ADDENDUM 7

Replacement Key Biscayne Library Branch

C25-MDPLS-KB-ESP

ADDENDUM NO. 7
19-SEPT-2025

GROUND FLOOR FFE PLAN

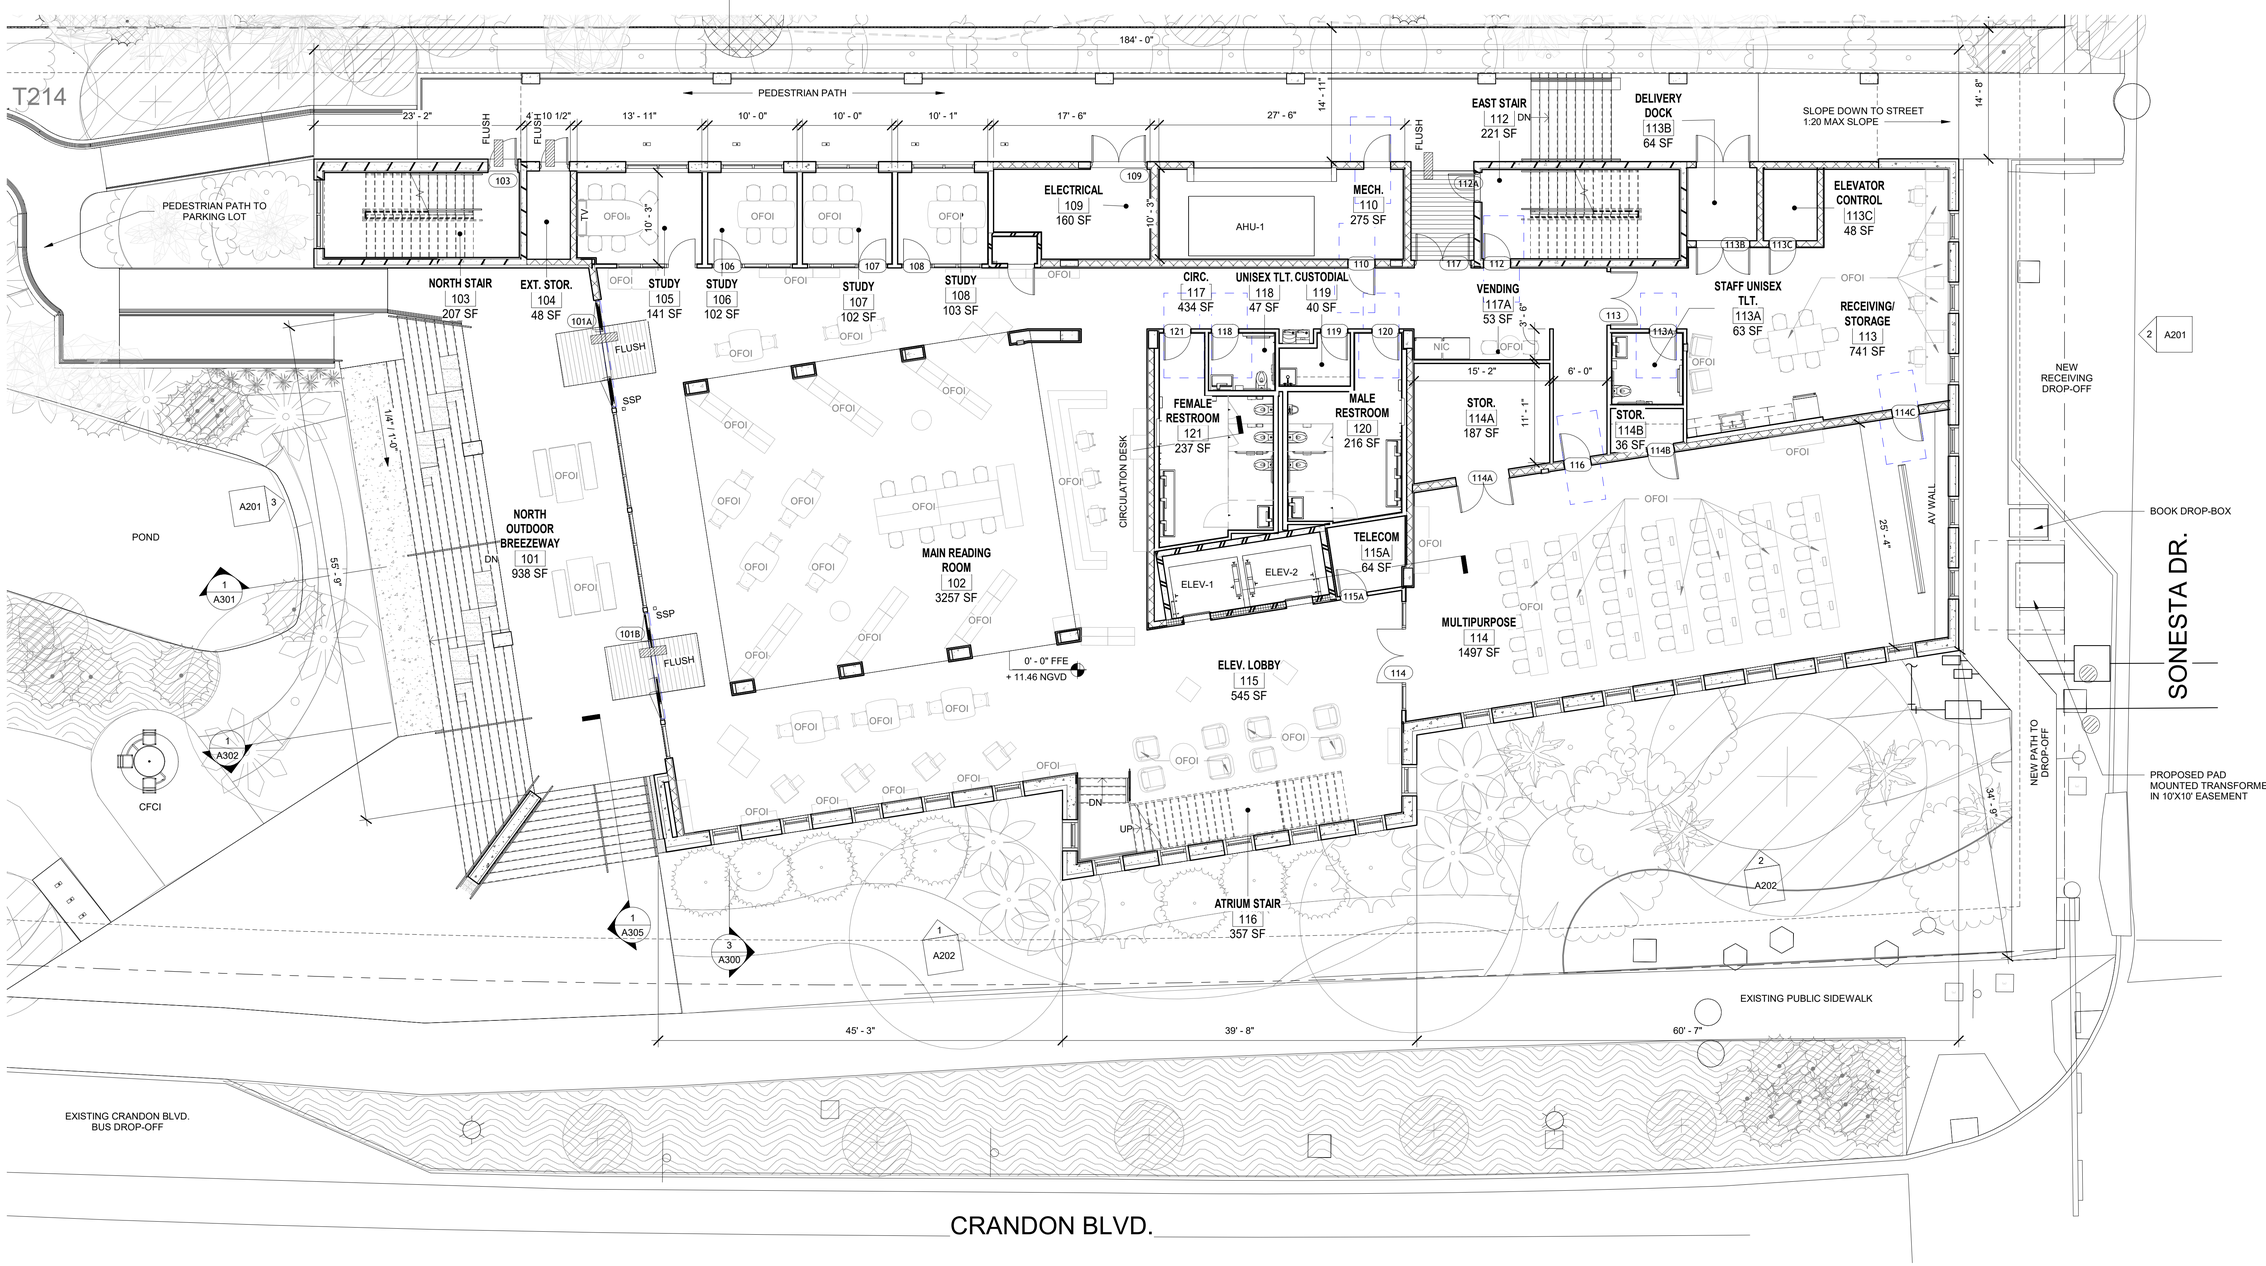
Q137. Sheets A108 and A109 note that any furnishings shown in half-tone are to be furnished and installed by the Owner. The bathroom stall partitions appear to be shown in half-tone on these sheets.
Please confirm whether the bathroom stall partitions will be furnished and installed by the Owner, or if this scope is to be included under the Contractor's responsibilities.

A137: Bidders are encouraged to look through the entire bid package. The contractor shall include in their bid all labor, materials, equipment, and work indicated in the drawings and specifications, except where explicitly noted as "Not in Contract (NIC)." The absence of a label does not exempt any item shown or described from the contractor's scope of work. Bathroom partitions are not considered furniture; this scope is to be included in the Contractor's responsibilities.
